Haverford Township - Planning Commission

**RE: Preliminary/Final Subdivision Plan
CMC Havertown LP- The Crossbar**

As requested, we have reviewed the following prepared by Linn Architects in connection with the referenced property:

- *"Preliminary/Final Subdivision/Land Development Plan- The Crossbar"* (four sheets) dated March 27, 2025.
- *"Stormwater Management Report for 2225 Darby Road"* dated March 27, 2025.

SITE PLAN

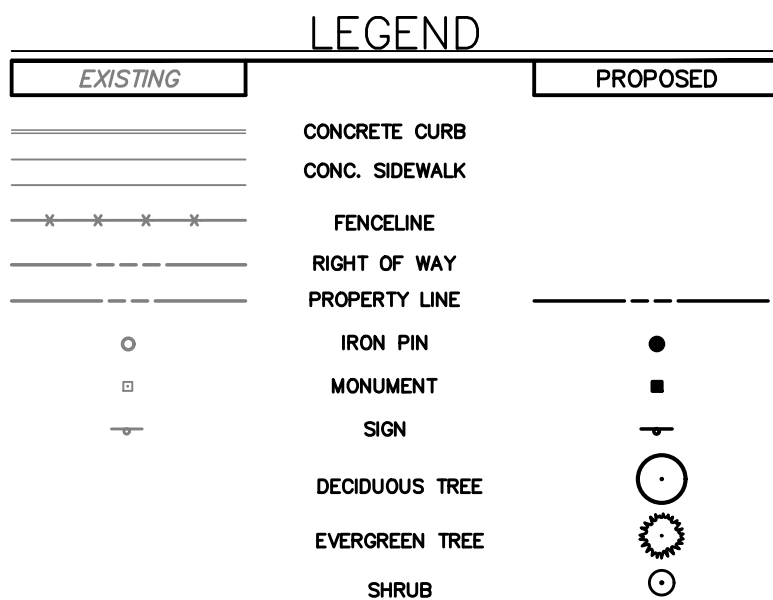
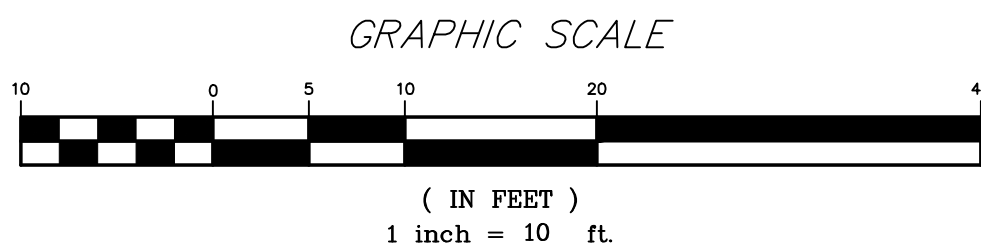
1. The required front, side and rear yard setbacks should be indicated on the plan. The proposed building height should also be specified. (§182-404.C)

3. The location, names and widths of streets, curbs and pavement (public or private), all property lines and names of owners of tracts or parcels located within 200 feet of the site should be provided. (§160-4.E(5)[e](3))

7. A Drainage Plan Application and Checklist are required to be provided. (§78-26.A(7))
8. A tabulation of existing and proposed impervious surface should be provided on the plan. (§78-25.B(7))
9. Existing and proposed utilities should be indicated on the plan. (§78-26.B(5))
10. The municipal signature block as set forth in §78-26.B(24) is required to be included on the plan.
11. A north arrow is to be provided on the plan. (§78-26.B(13))

14. The access easement is indicated as proposed. Provide documentation that the easement has been acquired.
15. A note should be added to the plan indicating that any substandard curb and sidewalk is to be replaced.
16. The limit of disturbance appears to be very conservative. It is unclear whether this includes any necessary utility replacement/installation or laydown/stockpiles areas. Please clarify.
17. The proposed ADA accessible space is indicated as "*an area with additional asphalt for drainage from the building*". Provide additional information on what this entails.
18. It may be prudent to re-stripe the parking stalls to ensure that all parking remains within the property.
19. If approved, a Grading, Drainage, Soil Erosion and Sedimentation Control Permit will be required.

CONCRETE CURB DETAIL

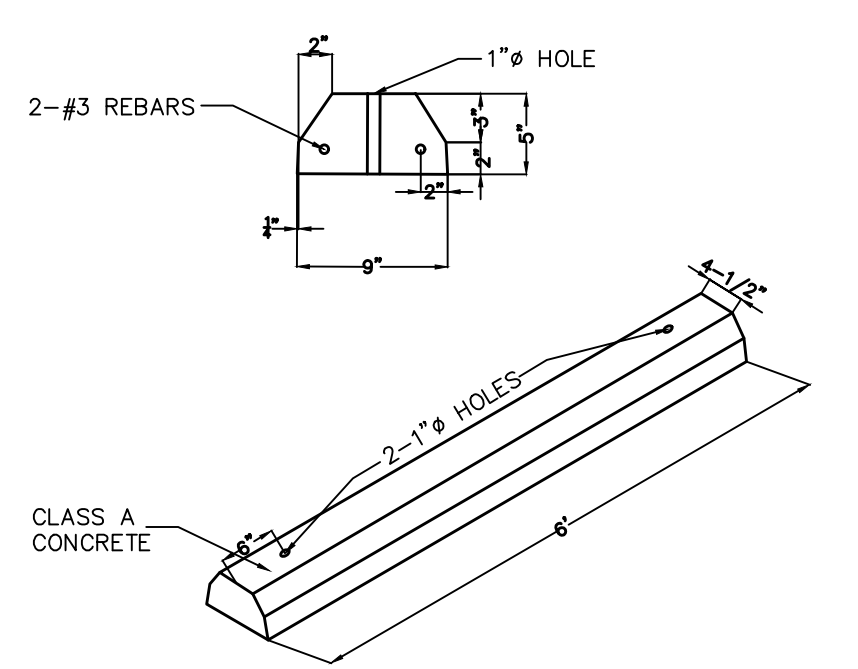
- 160-4.A To submit as a preliminary/final application
- 160-4.E.5(1) Traffic Impact Study
- 160-4.E.5(e)(4) Requiring depiction of storm, sanitary, and water lines within 400' of the project
- Curbs - requiring an 8" reveal for curbs

- From §160-4.A requiring a two-step preliminary/final plan approval procedure.
- From §160-4.E(5) requiring a traffic impact study.
- From §160-4.E(5)[e](4) requiring all storm, sanitary and water lines within 400 feet of the site to be depicted on the plans.
- From the Haverford Township Design Standards requiring an 8-inch curb reveal.

4. **HAVERFORD TOWNSHIP DESIGN STANDARDS FOR CURBS:** REQUIRING AN 8-INCH REVEAL FOR CURBS, THE APPLICANT IS REQUESTING A WAIVER TO ALLOW FOR A 6-INCH CURB REVEAL DUE TO THE SIZE AND SCOPE OF THE PROJECT, AND EXISTING SITE TOPOGRAPHY.
